**In Response to CEC & BLM Data Requests 128-141
Set 2, Part 1
Application for Certification (08-AFC-5)
SES Solar Two, LLC**

Subject: SES Solar Two (08-AFC-5)
Responses to CEC and BLM Data Requests 128-141
URS Project No. 27657106.00608

SES Solar Two
In Response to CEC and BLM Data Requests
Set 2, Part 1
Data Requests 128-141
08-AFC-5

PROJ. NO: 27657106.00608

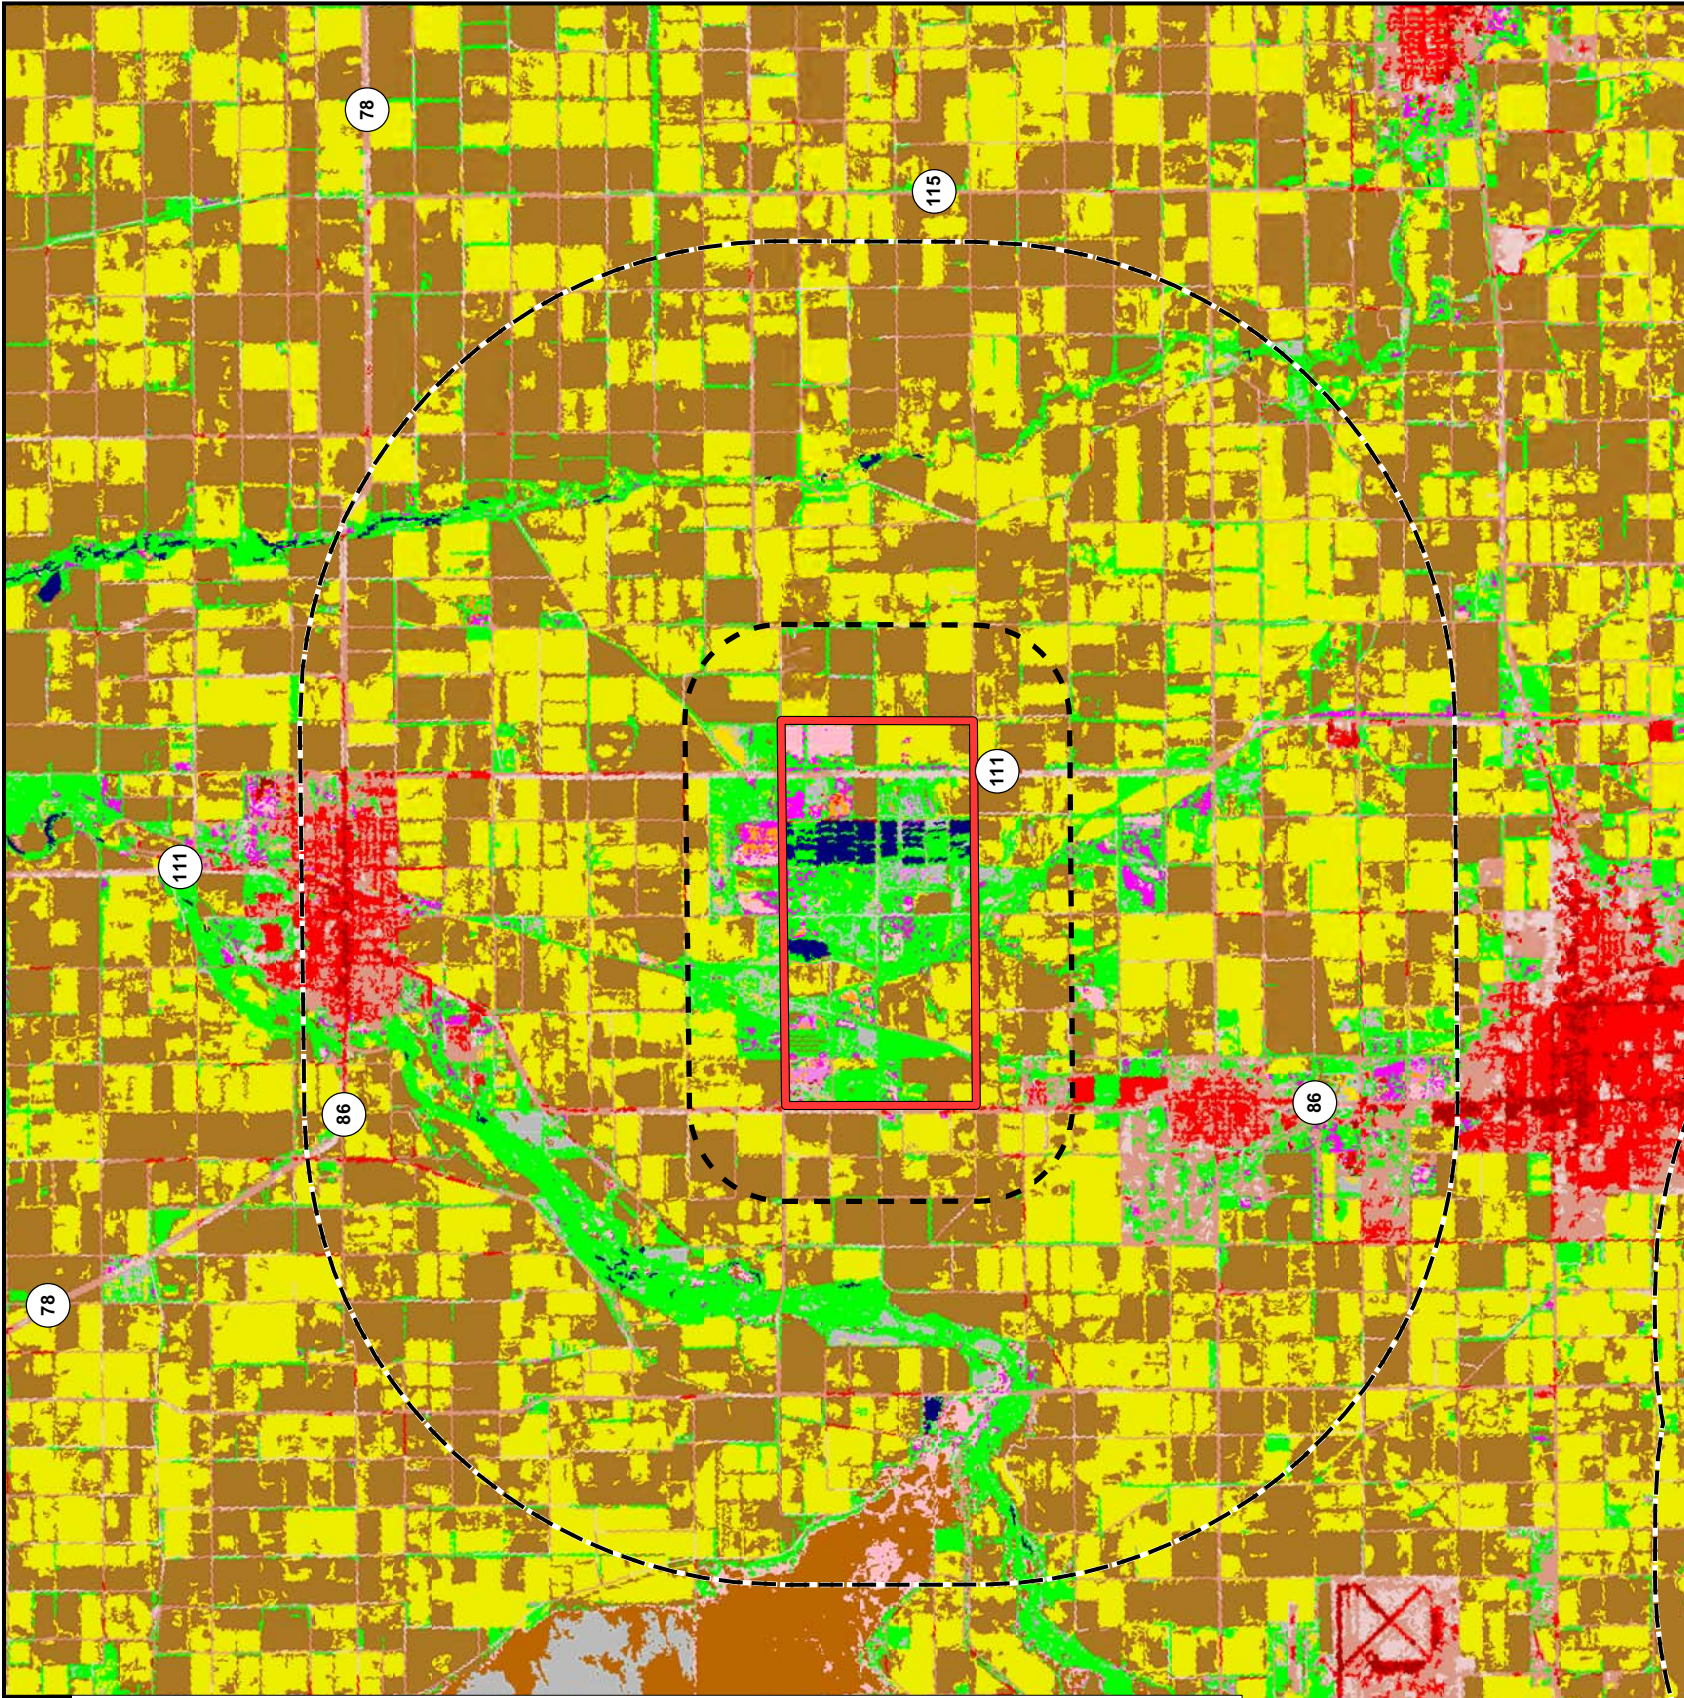
- **Biological Resources:** One of the site selection criteria for the proposed SES Solar Two site was to avoid highly pristine or biologically sensitive areas. In order to assess this criterion for the alternative sites, please provide the results of the CNDDDB search for the South of Hwy SR 98 site, the Mesquite Lake Alternative, and the Border Lands Alternative.
- **Cultural Resources:** Due to the extensive cultural resources present at the proposed SES Solar Two site, alternative sites are being sought that may impact fewer cultural sites while still achieving the required site criteria. Please provide an Information Center search (Class I) for recorded sites identified within the potential South of Hwy SR 98 site, the Mesquite Lake Alternative, and the Border Lands Alternative.

Mesquite Lake Alternative

The primary land cover of this alternative site is active and inactive agricultural lands, with some apparent desert scrub and arid riparian habitats. No sensitive species sightings occur within the immediate vicinity. Burrowing owl is likely to be present. A major drainage passes through the site. Please see Figures 134-3 and 134-4, provided behind this response as attachments BIO-4 and BIO-5, respectively.

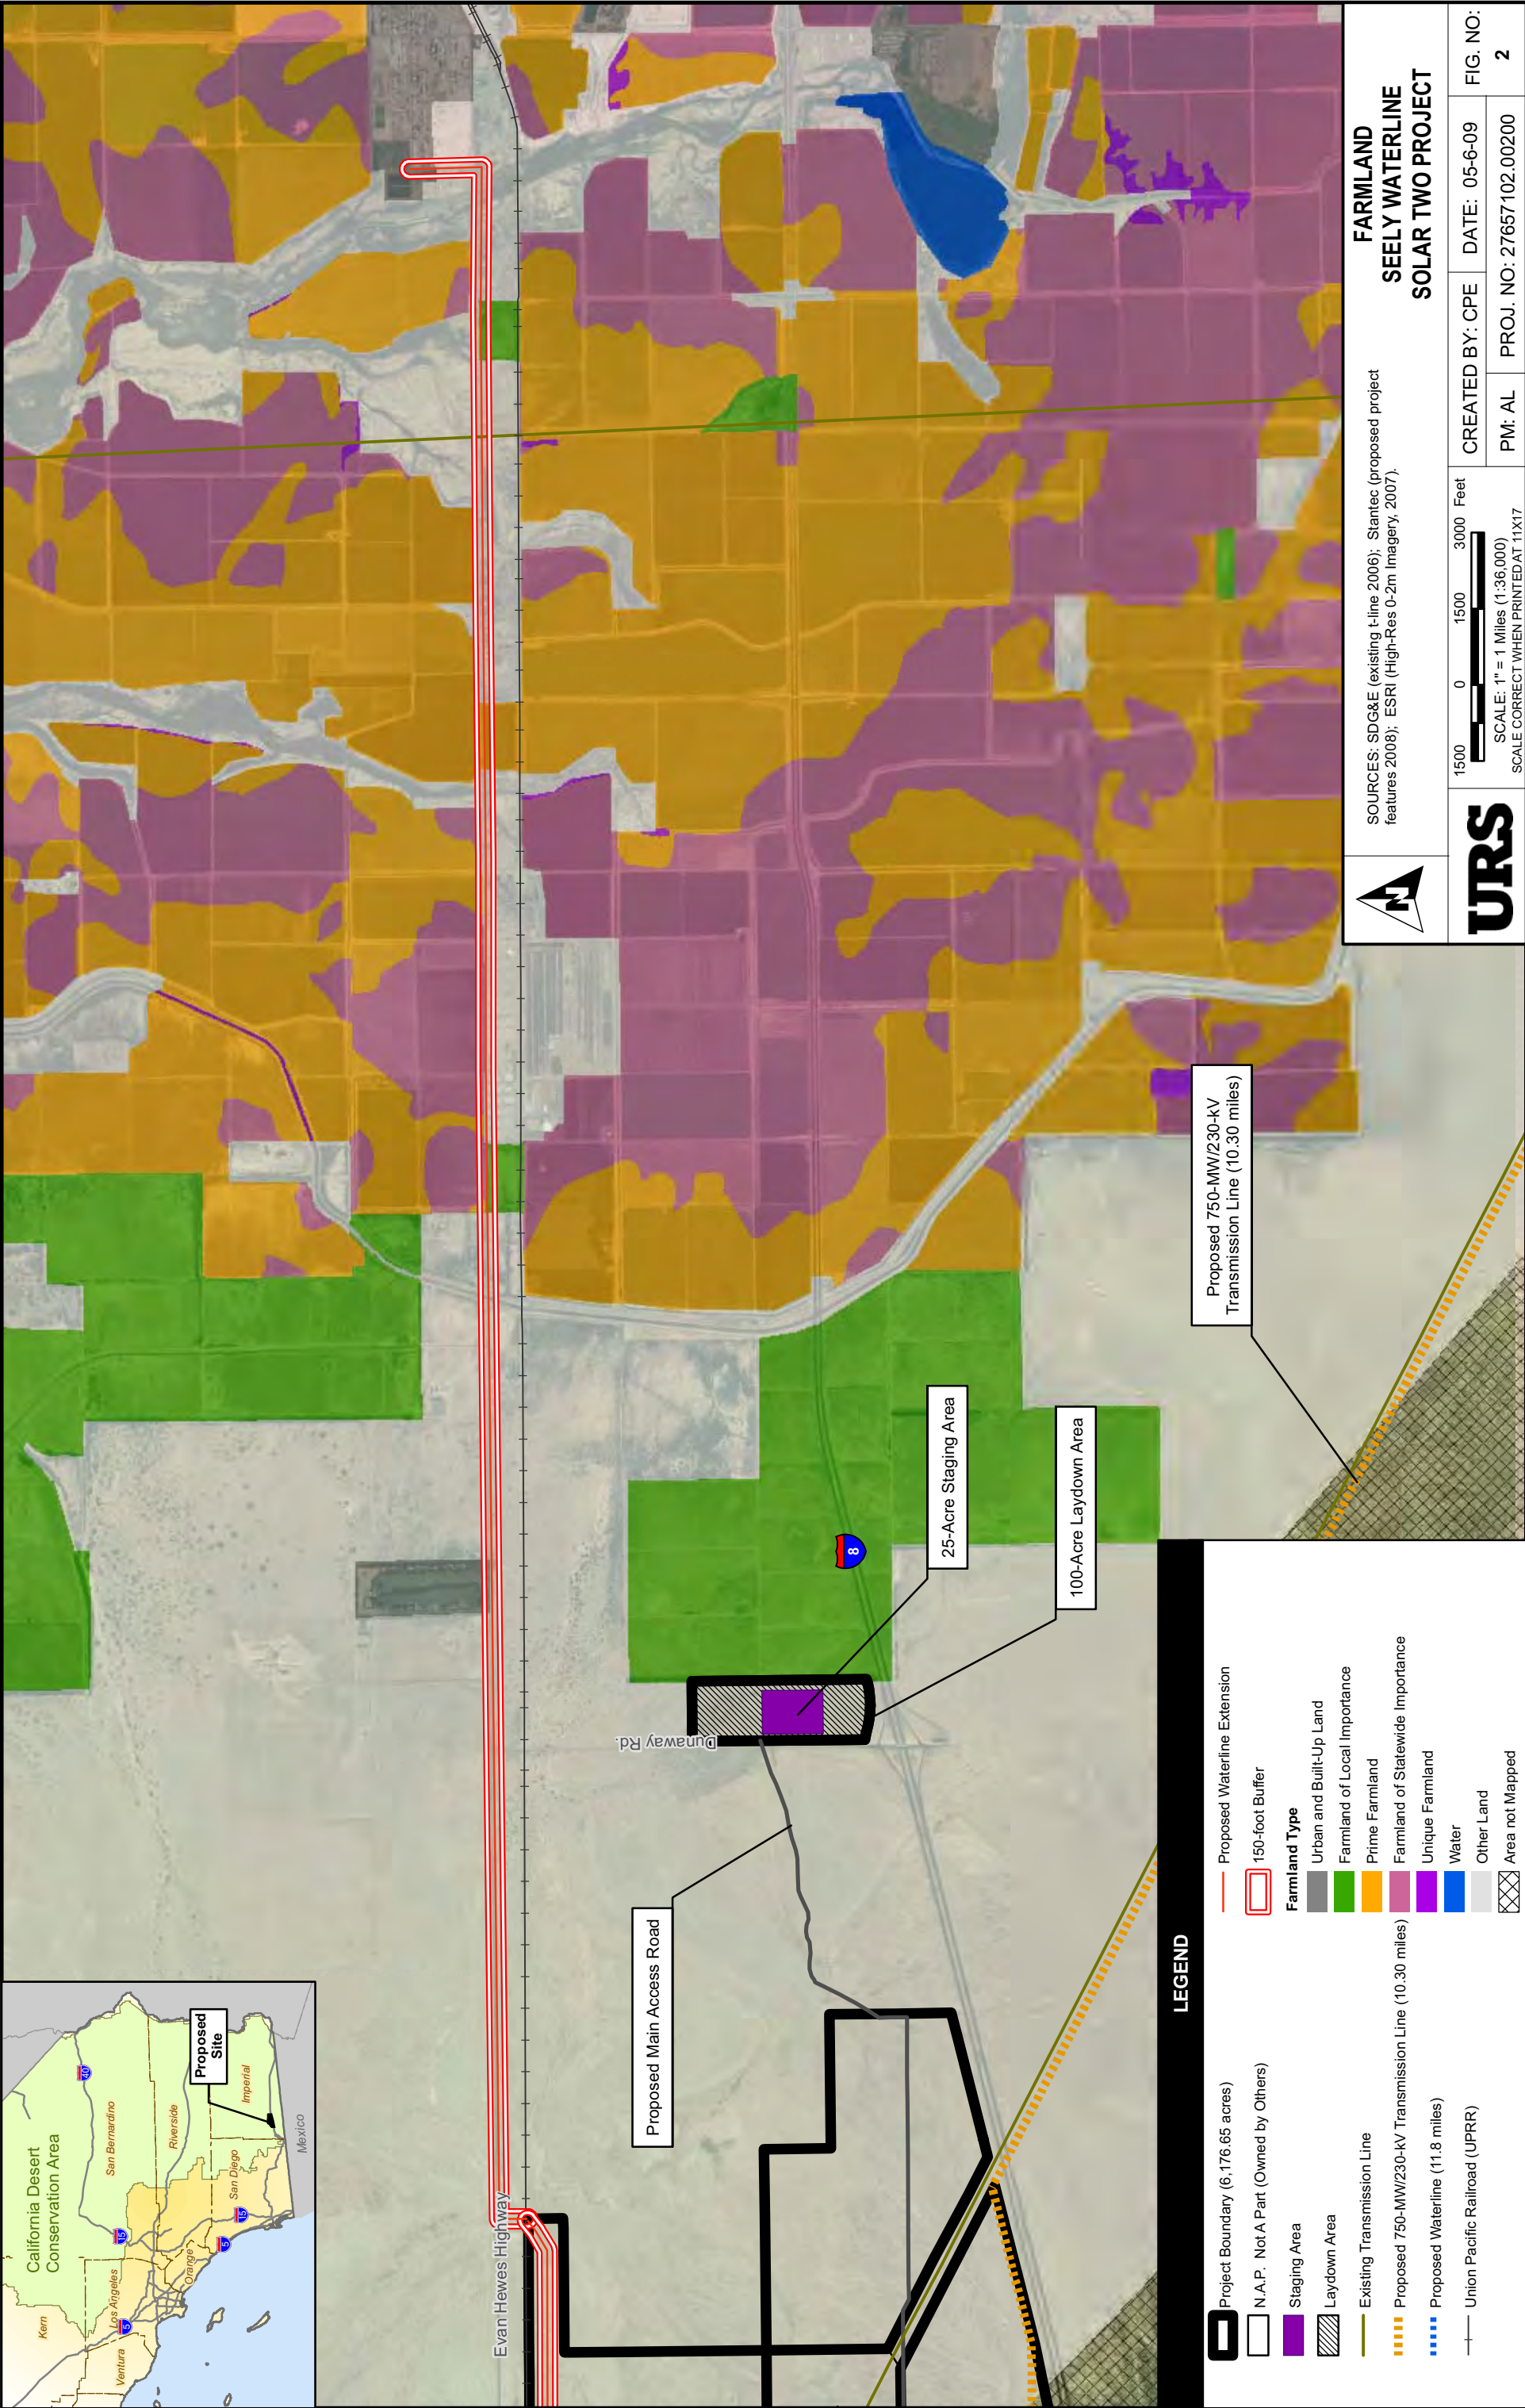
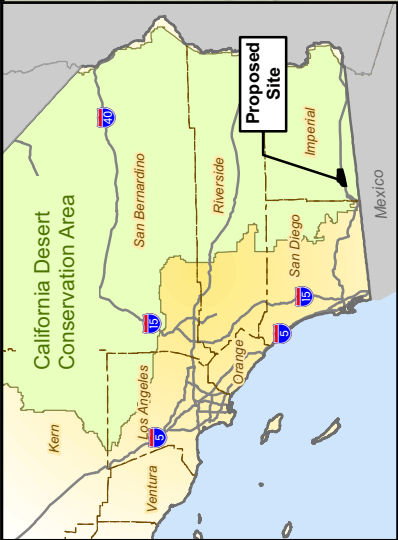
Data Request 136: Please verify whether construction of this pipeline would occur in the area proposed in AFC Figure 5.9-2.

Response: The construction of the pipeline as shown in Figure 5.9-2 has been updated to use reclaimed water from the Seeley Wastewater Treatment Plant. The Applicant is scheduled to docket a supplemental filing (Q2 2009) to include a description of the new water source which will include a description and figures of the new waterline location.
